LAKE NONA TELECOMMUNICATION TOWER

Applicant's Request: Specific Parcel Master Plan (SPMP) approval for a 165 foot monopole telecommunication tower on proposed within Lake Nona PD just south of the UCF Medical School.

Updated: August 28, 2015

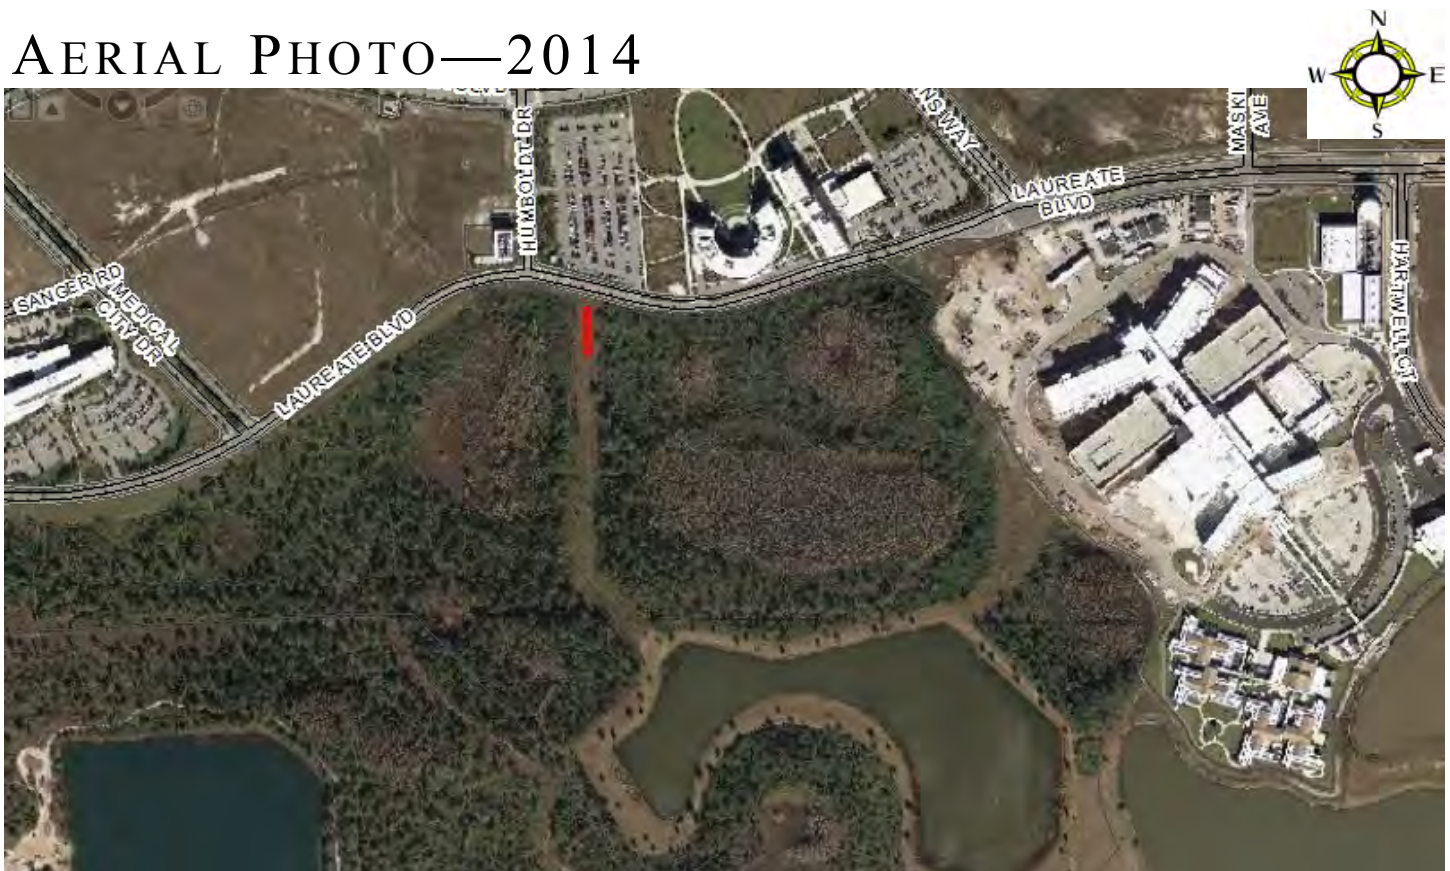
For this proposal, all communication tower equipment buildings and structures over 100 square feet shall conform to the AC-2 zoning district setback requirement. The AC-2 zoning district requires a front, side, and street side yard setback of 0 ft. and a rear yard of 10 feet. According to the site plan, there are 4 cell provider equipment structures that are 600 square feet each. There is a 217 foot setback from Laureate Boulevard, a 0 foot setback on the sides, and a 13 foot setback in the rear. There is also a 13 foot distance between structures on the opposite sides of the cell tower. And there is a 26 foot separation between the two interior structures and the cell tower. This meets the requirement for equipment buildings.

BOUNDARY & TOPOGRAPHIC SURVEY

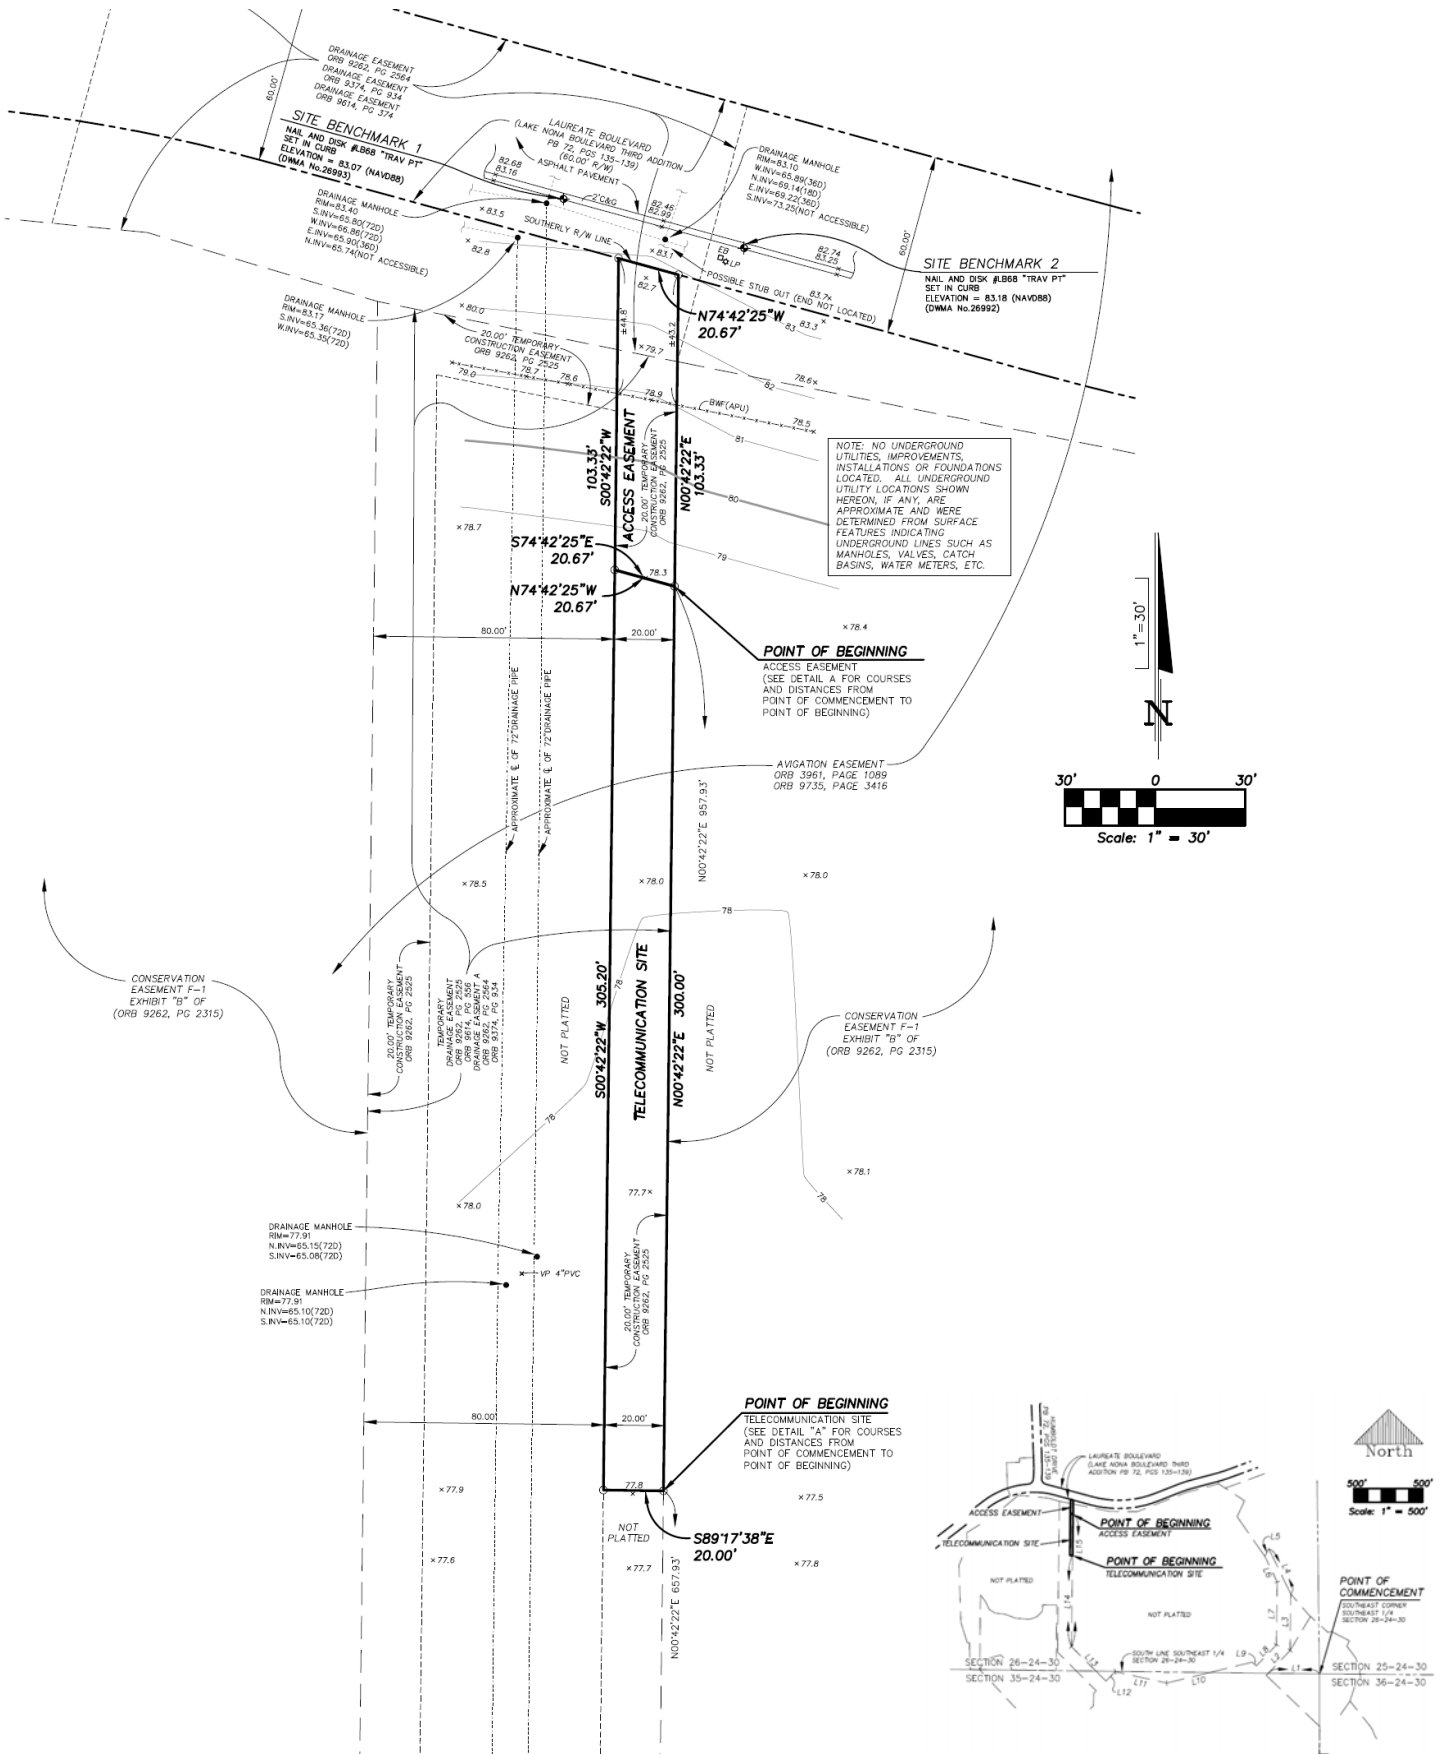
According to LDC Section 58.844(f), a fence or masonry wall not less than 8 feet in height from finished grade shall be provided around the perimeter of all communication tower sites for ground-mounted communication towers. The fence shall be constructed of chain link, wire mesh, metal picket, or an alternative material. Access to the communication tower site shall be through a locked gate. The proposed site plan depicts an 8 foot chain link fence surrounding the site. There are five 12 foot double chain link gates, one for each cell provider and the cell tower area which are on the at the west side of the site, which meets this requirement.
